MORGAN AND MORECAMBE OFFSHORE WIND FARMS: TRANSMISSION ASSETS

**Applicants' Response to Written Representations from Statutory
Consultees and other Organisations**

Deadline: Deadline 2
Application Reference: EN020028

Document Reference: S_D2_3
F01

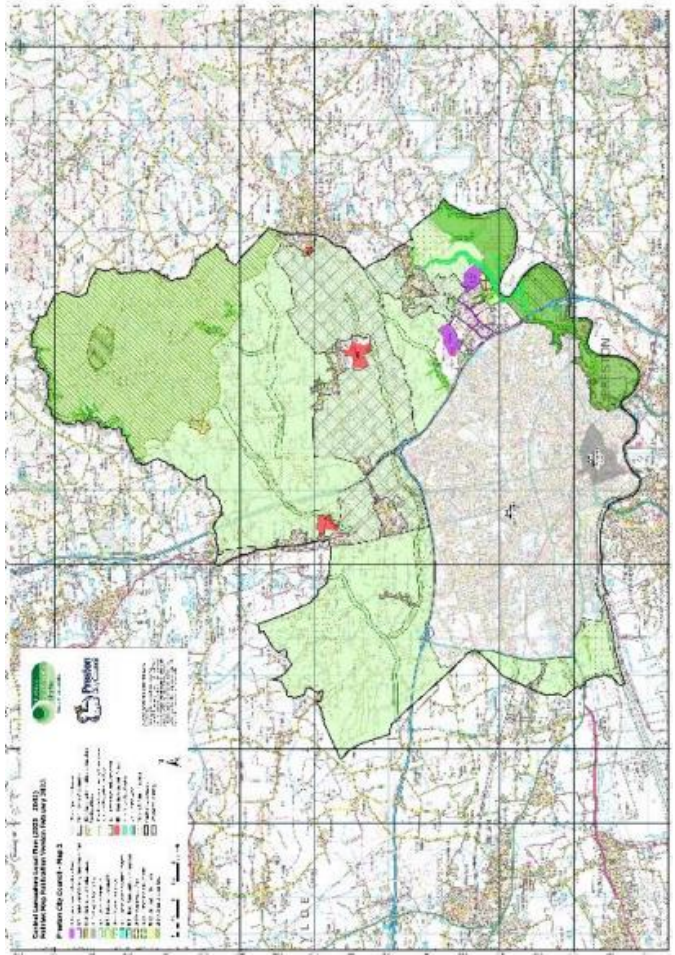
Reference	Written Representation Comment	Applicants' response
REP1-095 095.3	<p><u>2.2. Extent of the works within the City of Preston Cable Corridor</u></p> <p>2.2.1. The proposed transmission infrastructure would include approximately 630m of cable corridor which would enter on the western boundary of Preston, south of the A583 Blackpool Road. The cable corridor would travel under the Savick Brook, which runs in a north-south direction. The cable corridor would travel in an easterly direction heading slightly northwards to avoid Lea Marsh. Once past Lea Marsh the cable corridor would turn southwards and travel towards the River Ribble. This first phase of the corridor would travel through agricultural land.</p> <p>2.2.2. The 265m of cable corridor prior to the River Ribble would travel through a motor sports site known as Phoenix Park. The Phoenix Park site has planning permission for motocross and go karting uses and allows camping related to operations at the site including those attending competitions (06/2021/1413) and children receiving education and training (06/2024/0822) at the site.</p> <p>2.2.3. The proposed cable corridor would then travel under the River Ribble and into the authority area of South Ribble.</p>	<p>The Applicants note Preston City Council's response, .</p> <p>Specifically, the following comments are provided in response to 2.2.2:</p> <p>Application 06/2021/1413: Trax Motor Sport, the motor sport site at Phoenix Park, was operational at the time of the DCO submission, and is thus considered as a part of the baseline.</p> <p>Application 06/2022/1110, which is the original reference number for application 06/2024/0822 and an amendment to planning permission 06/2022/1110, comprised changes to the wording of condition no.2 (non-material amendment not subject to consultation). This has been considered in the CEA at the ES submission stage (refer to ID number 820, Volume 1, Annex 5.5: Cumulative screening matrix and location plan of the ES (REP1-020)).</p>

Reference	Written Representation Comment	Applicants' response
	<p>Figure 4 – Local Plan 2012-2026 Policies Map (double click map to enlarge)</p>  <p>Town Hall Lancaster Road PRESTON, PR1 2RL</p>	
REP1-095	3.2. Emerging Development Plan	The Applicants note Preston City Council's response.

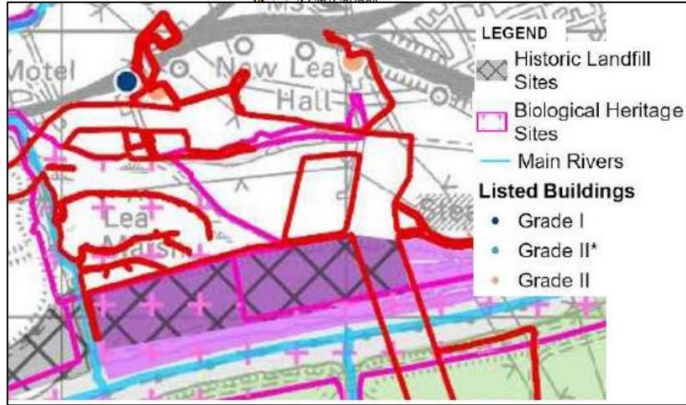
Reference	Written Representation Comment	Applicants' response
095.5	<p>3.2.1. As noted in the introduction, a new Development Plan is being developed for Preston City Council, which is expected to reach Regulation 19 on the 30th January 2025 following consideration at the City Council's Full Council meeting. The new Development Plan is expected to be adopted in December 2026. The following proposed policies should therefore be considered as part of the proposal, extracts are provided in Appendix A:</p> <p style="text-align: center;">Emerging Development Plan</p> <hr/> <p>Policy SS1 Development Patterns</p> <hr/> <p>Policy EC9 Skills and Economic Inclusion</p> <hr/> <p>Policy EN4 Amenity</p> <hr/> <p>Policy EN5 Green Infrastructure</p> <hr/> <p>Policy EN6 Biodiversity Net Gain</p> <hr/> <p>Policy EN7 Designated Sites for Nature Conservation</p> <hr/> <p>Policy EN8 Trees, Woodlands and Hedgerows</p> <hr/> <p>Policy EN9 Species Protection</p> <hr/> <p>Policy EN10 Development and Flood Risk</p> <hr/> <p>Policy EN13 Heritage Assets and Archaeology</p> <hr/> <p>Policy EN14 Environmental Quality</p> <hr/> <p>Policy EN16 Protection of Agricultural Land</p> <hr/> <p>Policy EN17 Development in the Open Countryside</p> <hr/> <p>Policy EN19 Landscape Character</p> <hr/> <p>Policy CC1 (Strategic Policy): Climate Change</p> <hr/> <p>Policy CC2 Renewable Energy Generation and District Heating Networks</p> <hr/> <p>Policy ST1 (Strategic Policy): Strategic Transport Priorities</p> <hr/> <p>Policy ID1 (Strategic Policy): Infrastructure Planning Principles</p>	<p>The Applicants also refer Preston City Council to the Applicants' response to Hearing Action Point ISH1 2: Planning Statement Addendum (S_D2_9).</p>

Reference	Written Representation Comment	Applicants' response
	<p>Figure 5 – Emerging Development Plan Policies Map (double click map to enlarge)</p>

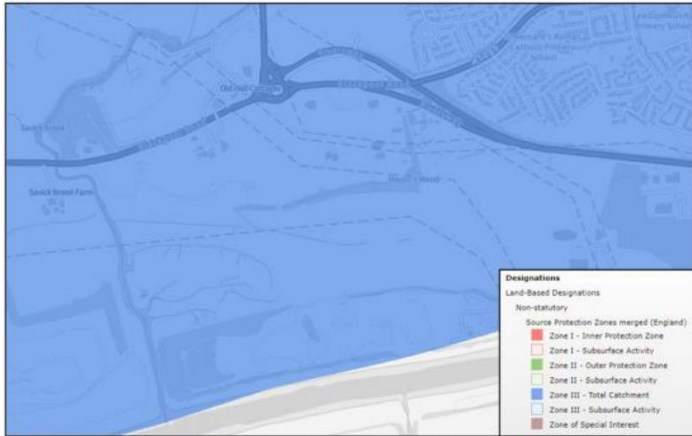
Reference	Written Representation Comment	Applicants' response
REP1-095 095.6	4. COMMENTS ON THE PROPOSED WORKS 4.1. Landscape 4.1.1. The proposed cable corridor would be located in the open countryside within the National Character Area 'Lancashire and Amounderness Plain' and MCA 34: Blackpool Coastal Waters and Ribble Estuary.	The Applicants refer to response RR1775.1 provided in Procedural Deadline A Submission - Annex 3.2.22 to Response to RR – Preston City Council (RR-1775) (PDA-029) and section 1.3.2.2 and Appendix A of ES Volume 3, Annex 10.2: Landscape character baseline technical report and ES Volume 3, Chapter 10: Landscape and visual resources which address these points.
REP1-095 095.7	4.1.2. This Development Consent Order is for a large-scale project and the submitted documents follows best practice making reference to Landscape and Visual assessment being in accordance with Visual Impact Assessment: Third Edition, 2013, Landscape Institute and Institute of Environmental Management and Assessment (GLVIA3). Additionally, Landscape Institute technical guidance notes are also referred to.	The Applicants thank Preston City Council for confirming that the Landscape and Visual Impact Assessment has followed best practice.
